**Assessment Report
State Significant Development Application
338 Pitt Street Sydney**

China Centre Development

State Significant Development Assessment SSD 10362
(Council reference D/2020/610) and D/2016/1509/A

March 2021

Figure 38 | The southwest tower has been designed to mitigate potential adverse privacy impacts in the event that 255 Castlereagh Street is developed for residential accommodation in future.

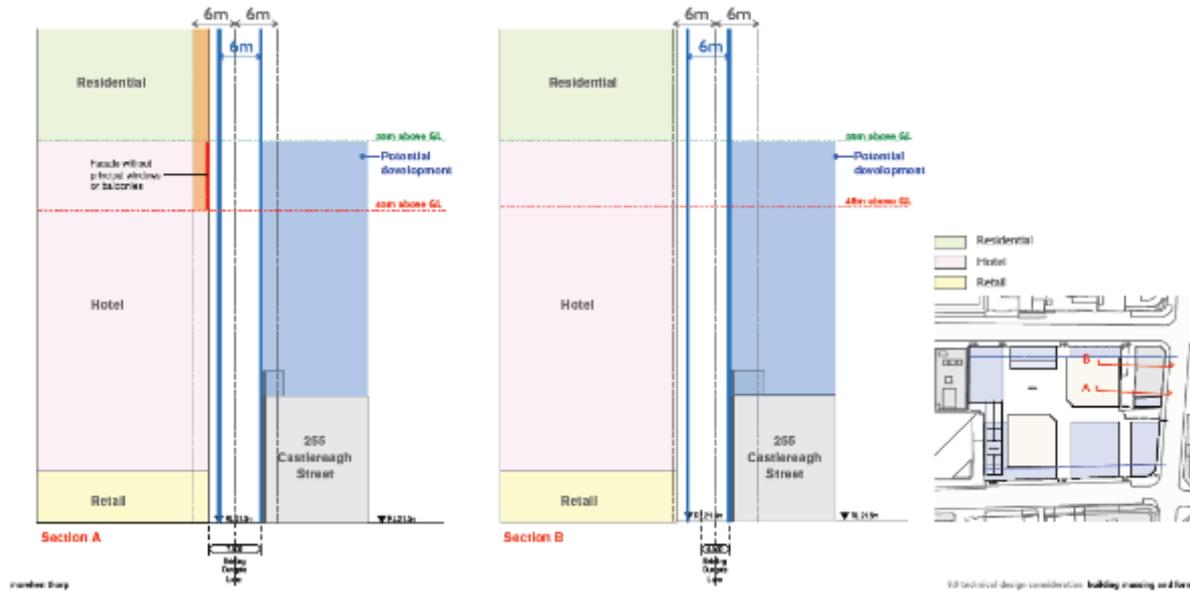
The development as amended does not comply with the minimum recommended setbacks.

Figure 40 | The concept envelope is required to be reduced to exclude the areas beyond the red lines.

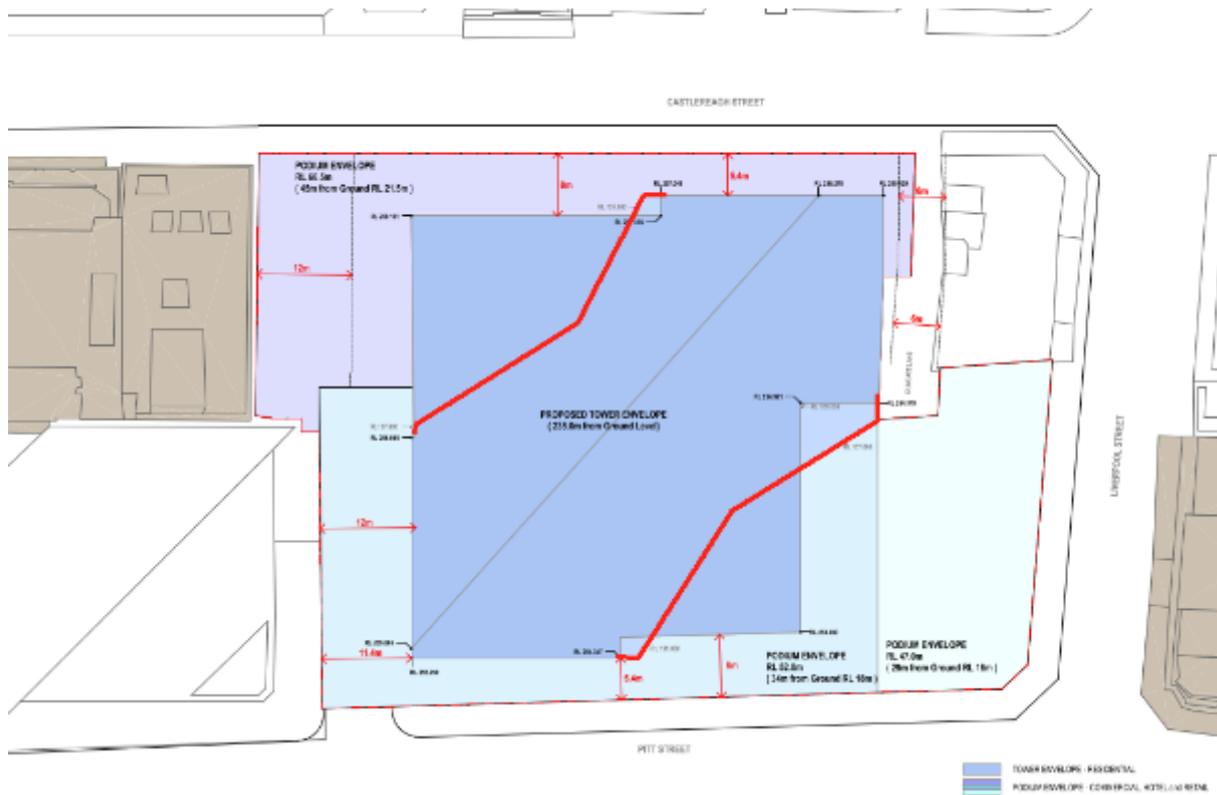
Subject to conditions, the proposed non-compliances may be acceptable.

Deletion of condition 4 is supported, subject to a new condition requiring the building envelope to be reduced as shown in **Figure 40**.

Figure 52 | A heat map demonstrating the amount of direct solar access a building will receive during midwinter between 9.00am and 3.00pm, illustrating the approved building envelope at 133 Liverpool Street and the original building envelope proposed at the subject site (Source: City of Sydney).

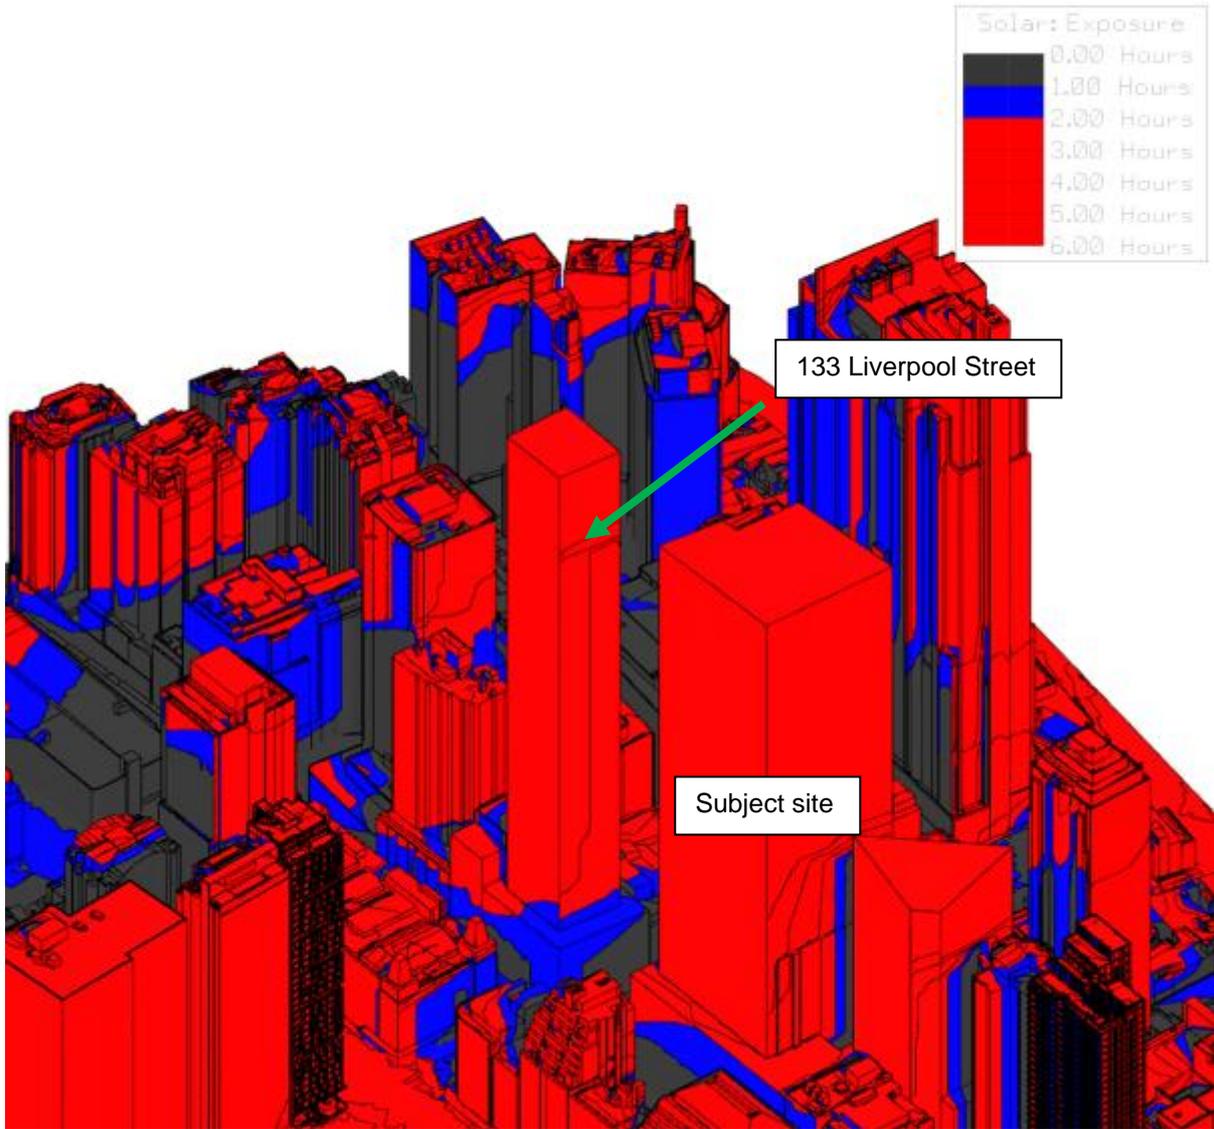
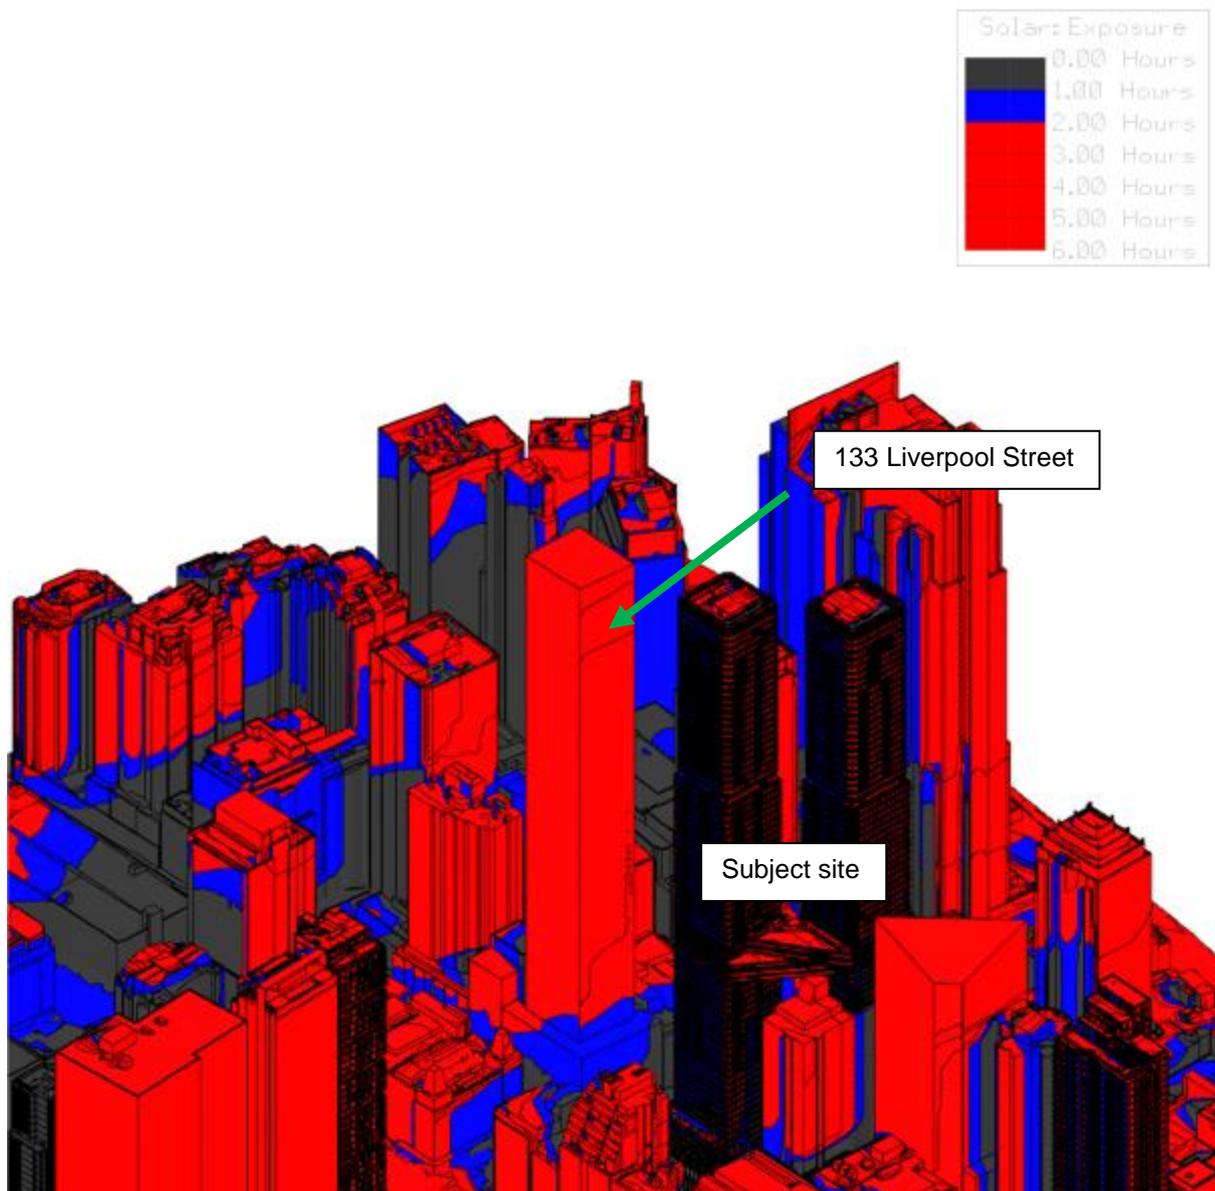
Figures 52 and **53** below compare the amount of direct solar access received to buildings under the original building envelope proposed for the subject site, and the proposed detailed design (note that the original building envelope for the subject site illustrated in **Figure 52** was reduced in scale as illustrated in **Figure 49** above). The areas in red will receive at least two hours direct solar access midwinter between 9am and 3pm. The diagrams demonstrate that there is little to no impact to solar access caused by the detailed design application. As such, the building envelope at 133 Liverpool Street can comply with Objective 4A-1 of the Apartment Design Guide.

As previously discussed, it is recommended that the concept envelope be amended to fit the extent of the towers and skybridge to secure the benefits, and overcome the impacts, of the redistributed bulk and non-compliant setbacks, see **Figure 40** above.

Figure 55 | The development will overshadow Harmony Park between 1.58pm and 2.00pm during the winter solstice (Source: FJMT)

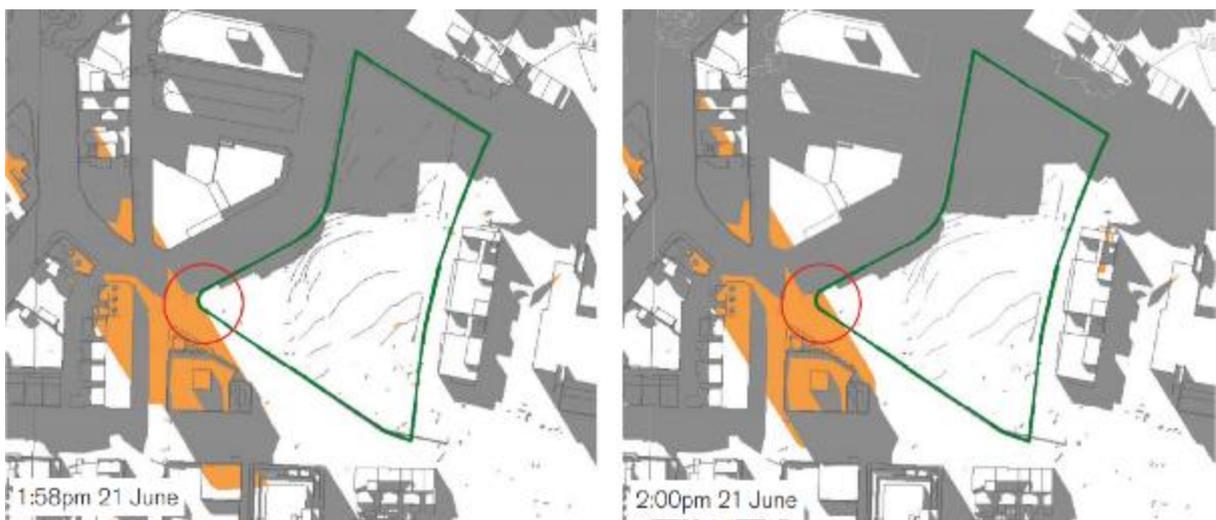
The proposed detailed design will result in overshadowing of Harmony Park between 1.58pm and 2.00pm, contrary to the proposed development control. The extent of shadow will reduce each additional day further from the solstice.

The applicant demonstrated in pre-submission discussions that the area of the building causing the overshadowing was a small portion of the tower as shown in the Figure below, and stated that it was unreasonable to require a cut-out to reduce the extent of overshadowing proposed. City staff acknowledge that the design reflects the winning design competition scheme, which was undertaken prior to the Central Sydney Planning Strategy becoming a matter for consideration, and that compliance with the draft standard would result in an unreasonable adverse impact to the design of the tower. As such, minor inconsistency with the draft controls is considered acceptable in this instance.

Figure 58 | The dotted red line was the previous extent of the bridge (Source: FJMT).

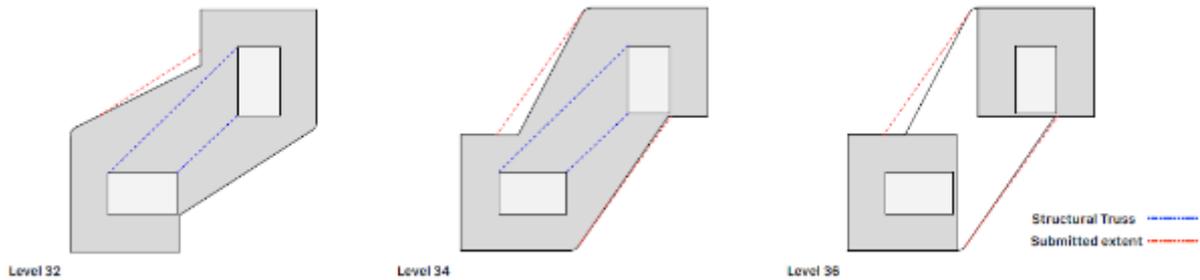
Issue	Findings	Recommendations
<p>Refinement of the form and location of the Sky Terraces linking the two towers including the height, the detail of the interface with the tower forms, and the relationship with the location of two vertical components of the towers. This will include consideration of suitable uses for the floors in the south tower, immediately below the Sky Terraces.</p>	<p>The applicant has provided revised plans during the assessment of the application reducing the scale of the skybridge such that it is only as wide as is recommended by the structural engineer to support the towers.</p> <p>The skybridge serves to segment the lower third of the towers, with an additional landscaped recess provided to the segment the middle and upper thirds, providing a rational design response.</p>	<p>The matter, as raised by the competitive design panel and Design Advisory Panel, has not been resolved to the satisfaction of the City. As such, a deferred commencement condition is recommended requiring the skybridge to be further reduced in size.</p>

A statement from a structural engineer and amended plans have been submitted during the assessment of the application, slightly reducing the scale of the skybridge. As discussed in **Table 6**, a deferred commencement condition is recommended requiring the skybridge to be substantially reduced further.

The width of the skybridge has been adjusted. The development comfortably exceeds the ADG minimum requirements for sun access to residential apartments. The spaces immediately below the skybridge have been replaced by plant areas. The apartments beneath the skybridge will still receive sun and have high levels of amenity through spectacular outlook and high levels of natural light. The apartments on level 36 have privacy separation from the communal area through landscape treatment and grade changes.

Figure 65 | The corner apartments are recommended to be used as either an extension of the communal open space or as common areas for residents due to poor visual privacy from the skybridge (Source: FJMT).

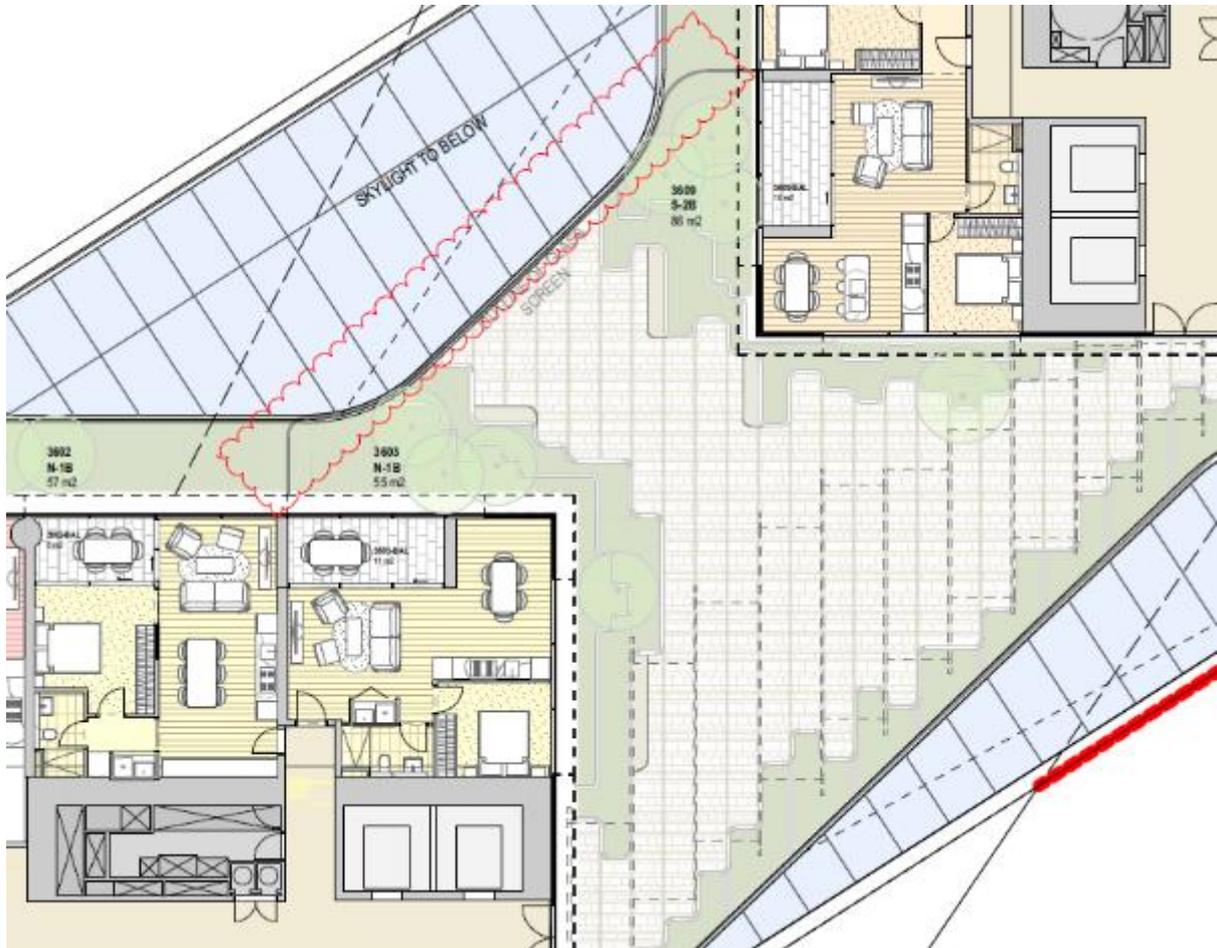
Issue	Findings	Recommendations
Visual privacy	<p>Objective 3F-2 of the ADG states that communal open space, common areas and access paths should be separated from private open space and windows to apartments, particularly habitable room windows. As shown in the Figure below, the open space of the skybridge directly adjoins habitable room windows of apartments.</p> <p>The applicant proposes a vegetative screen to provide visual separation between the skybridge and habitable</p>	<p>A condition is recommended requiring apartments 3603 and 3609 to be converted to communal rooms or a partially enclosed extension of the common open space.</p>

rooms of the apartments, however this is inadequate given the proximity of the open space and wind impacts on vegetation. Converting two of 592 apartments to greater common facilities/open space is not unreasonable.

Figure 66 | A diagram illustrating the architectural device within the windows to deflect views (Source: FJMT).

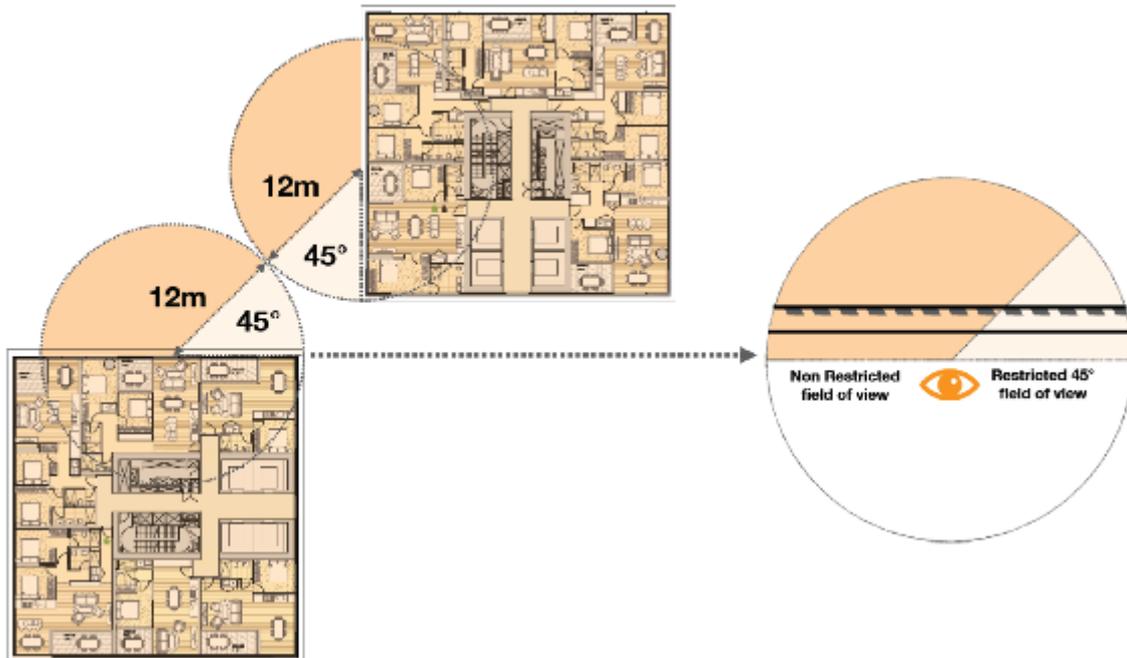
overlooking. **Figure 66** below illustrates how this will operate.
